ITEM NO.: 2

FILE NO.: S-309-G

NAME: Block 24, Gibraltar Heights- Replat

Future Land Use S-309-G

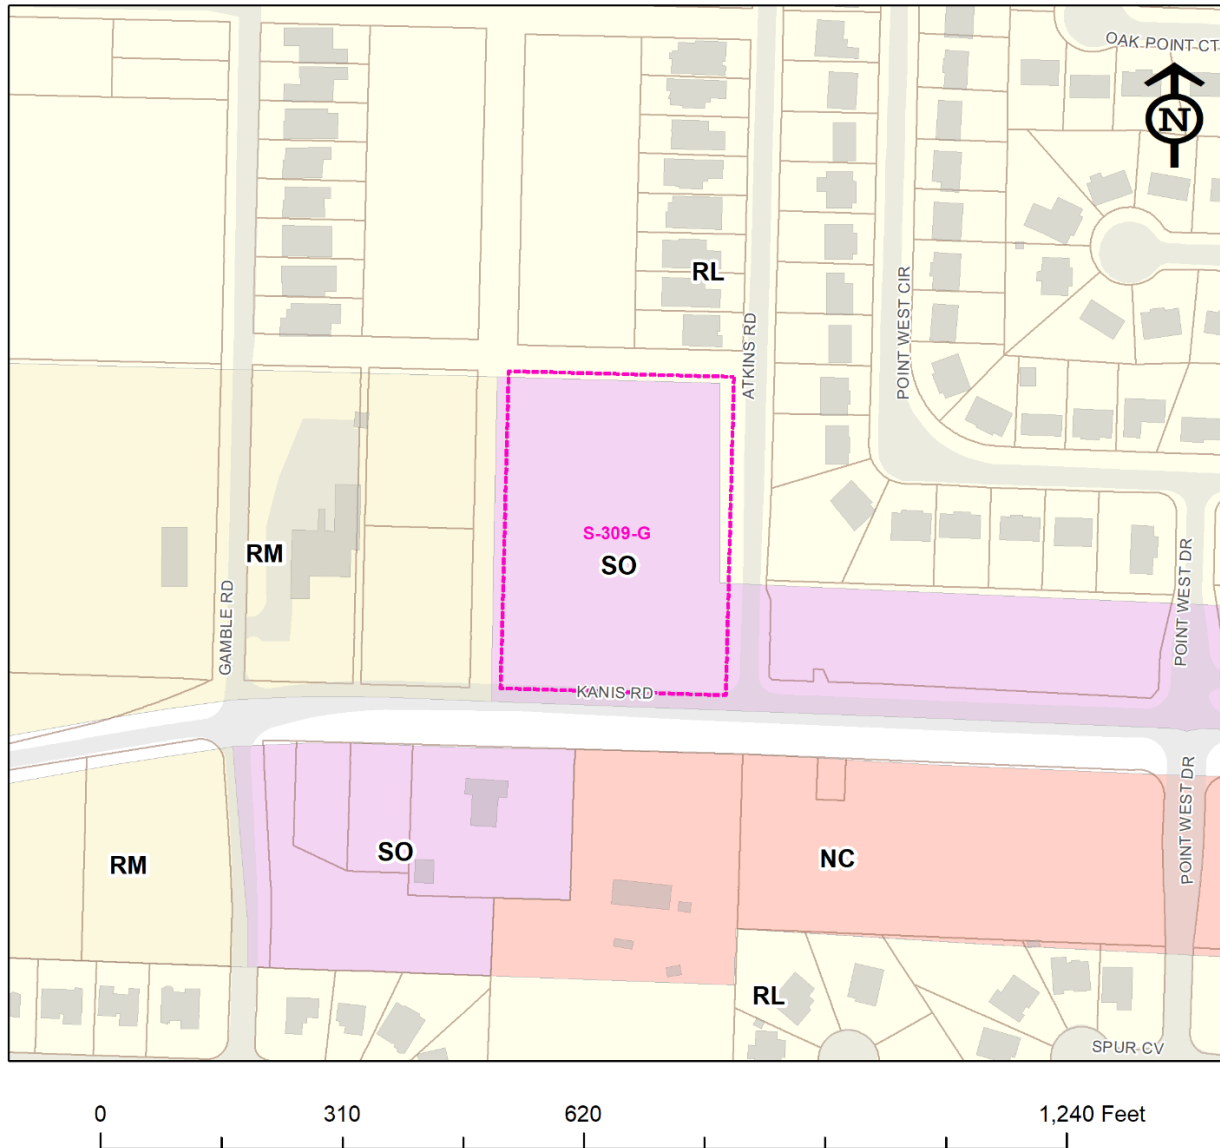
The request is in the Ellis Mountain Planning District. The Land Use Plan shows Suburban Office (SO) for the requested area. The Suburban Office (SO) category provides for low intensity development of office or office parks in close proximity to lower density residential areas. The application is for a 20-lot preliminary plat for a residential subdivision to be completed in two phases, with 414 linear feet of proposed Residential Street. This development will result in a residential density of 4.5 dwellings per acre.

The area north and northeast of the application site is designated for Residential Low (RL) use and is characterized by completed subdivisions. To the east, along the Kanis Road corridor, the land is designated for Suburban Office (SO) use but remains largely undeveloped. South of Kanis Road, the Land Use Plan identifies both Neighborhood Commercial (NC) and Suburban Office (SO) designations, which are also currently undeveloped. To the west, the area is designated for Residential Medium (RM) use and includes a Veterans of Foreign Wars (VFW) Post.

Master Street Plan S-309-G

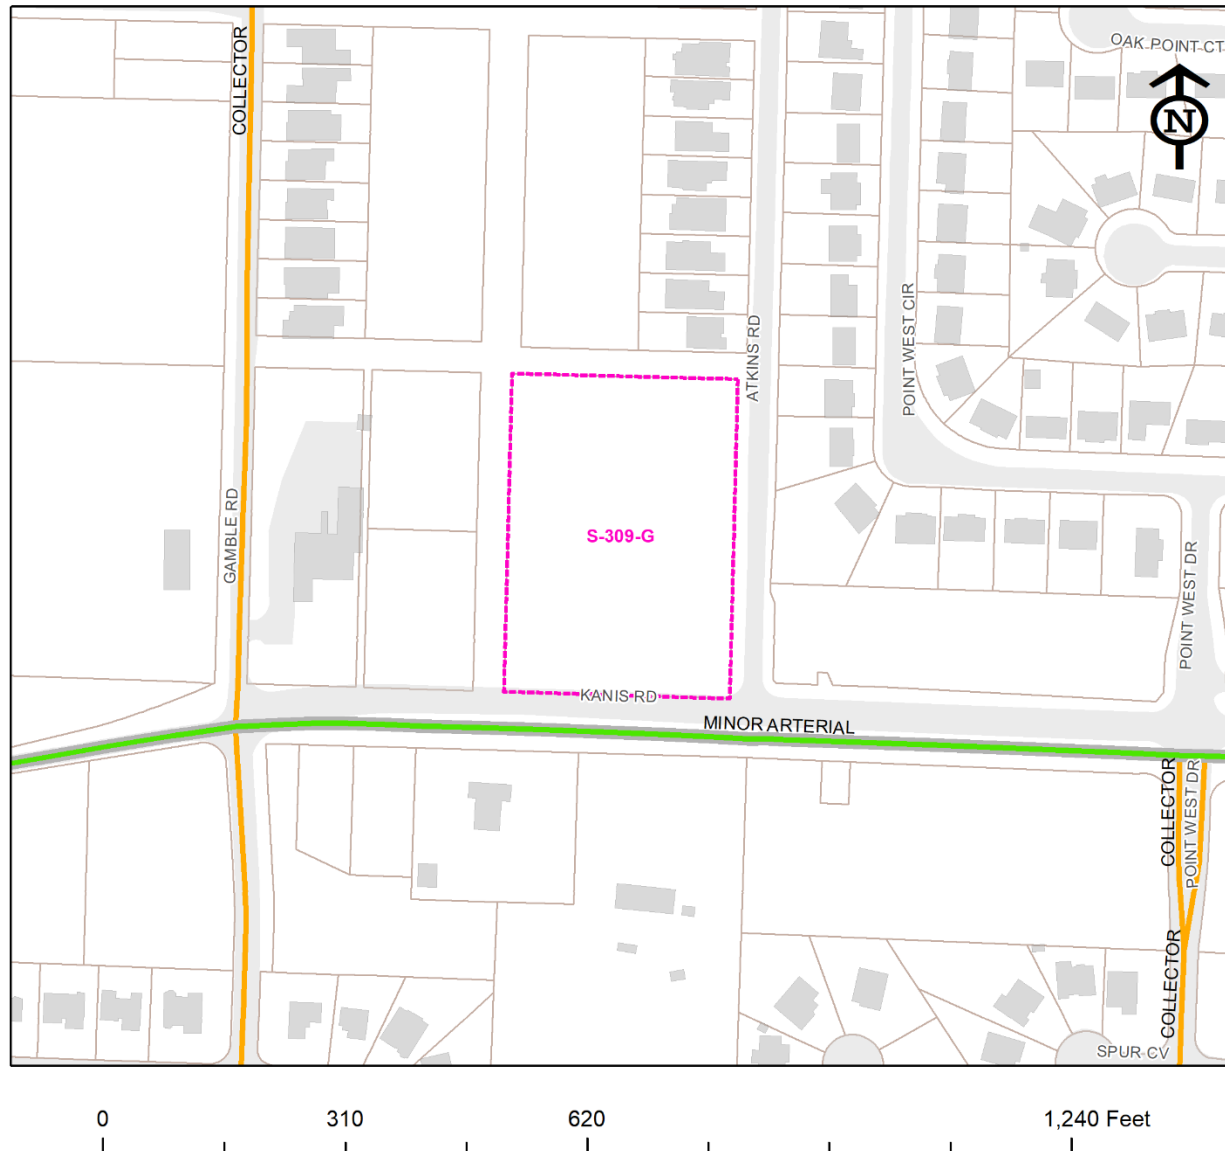
Kanis Road is designated as a Minor Arterial on the Master Street Plan. Minor Arterials are high volume roads designed to provide the connections to and through an urban area. Curb cuts should be minimized to allow for continuous traffic flow while still allowing some access to adjoining property. Deceleration Lanes may be required. Standard Right-of-way (ROW) is 90 feet. Sidewalks are required on both sides.

Atkins Road and the proposed Trumpler Street are Local Streets. Local Streets are roads designed to provide access to adjacent property with the movement of traffic being a secondary purpose. The standard Right-of-way is 50'. Sidewalks are required on one side.
